**Subject: CZ-19-0673-42 – Design Build Construction of Heating, Ventilation, and Air Conditioning (HVAC) at Multiple Sites – Package A (SDUSD Project # 90290071.1)**

## **Notice to Proceed: No. 16– Fix Broken Lights at Bird Rock Elementary School**

<b>Project:</b>	Bird Rock ES HVAC Phase 2	<b>Document:</b>	050
<b>Title:</b>	Building 03 Light Fixtures - Falling	<b>Sub Ref. No.:</b>	00
<b>Contract No.:</b>	CZ19-0673	<b>Date:</b>	05/06/2020
<b>From:</b>	Soltek Pacific	<b>Required Date:</b>	05/08/2020
<b>To:</b>	StudioWC	<b>Response Date:</b>	05/07/2020
<b>Plan Ref:</b>	N/A

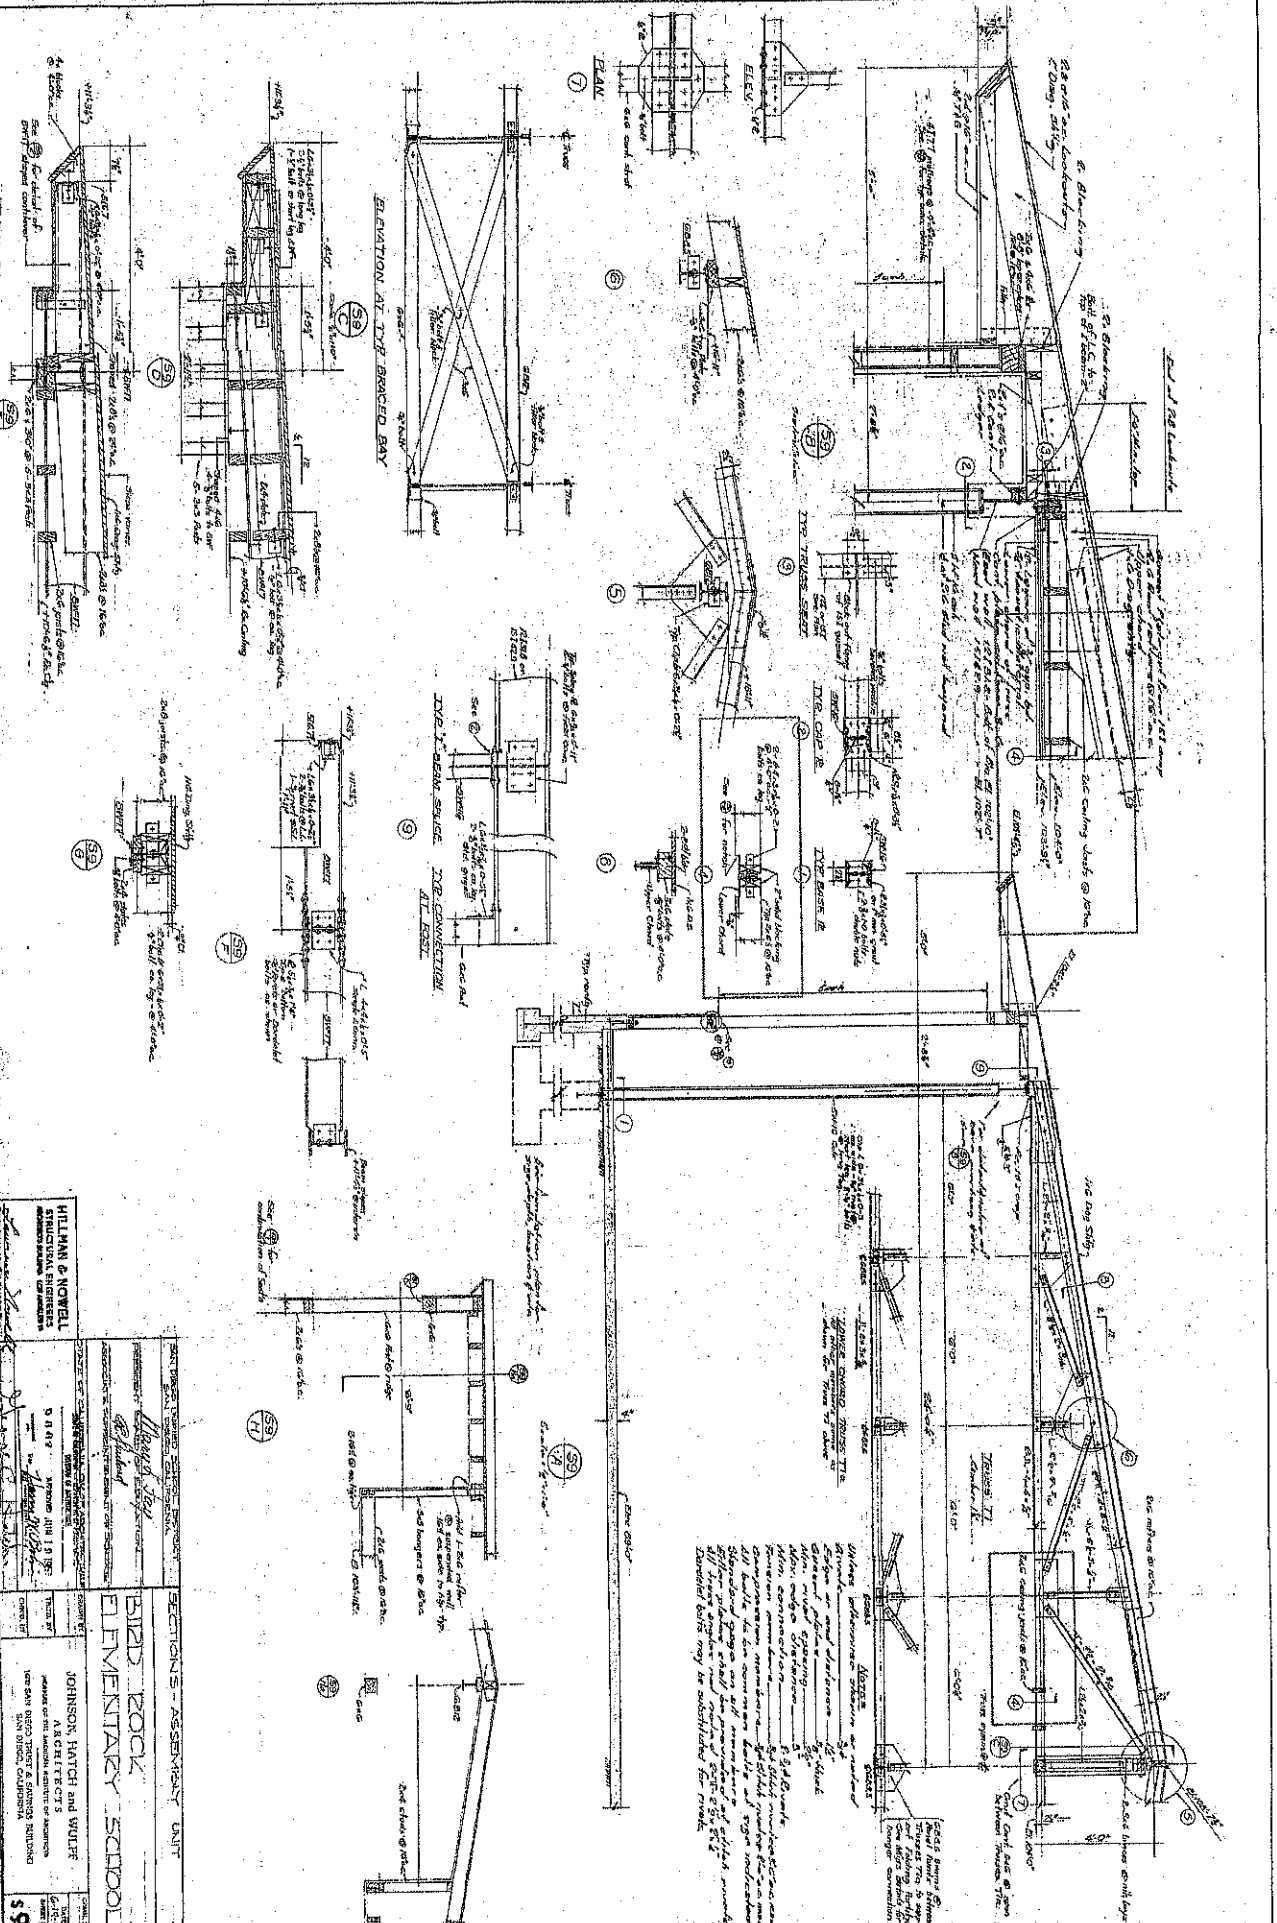
An existing line of light fixtures fell from the ceiling while the contractor was working in the adjacent area and on the roof. The lights were fastened to the drywall ceiling with toggle bolts and wood screws through ceiling tile glued to the drywall. See attached photos for reference.

What type of fasteners should be used and is it acceptable to fasten the lights to the ceiling joists for reinstallation of light fixtures that have fallen?  
Please advise.

The Ceiling construction is 2x6@ 16"o.c. running between the Steel roof trusses. If needed you can add 2x6 blocking with an A35 each end for fastening the light fixtures. Use #10 WS for fastening the light fixtures to the 2x6 ceiling or blocking members. The WS should be long enough to get 2" of embedment into the wood framing and be located in the middle 1/3 of the member width.
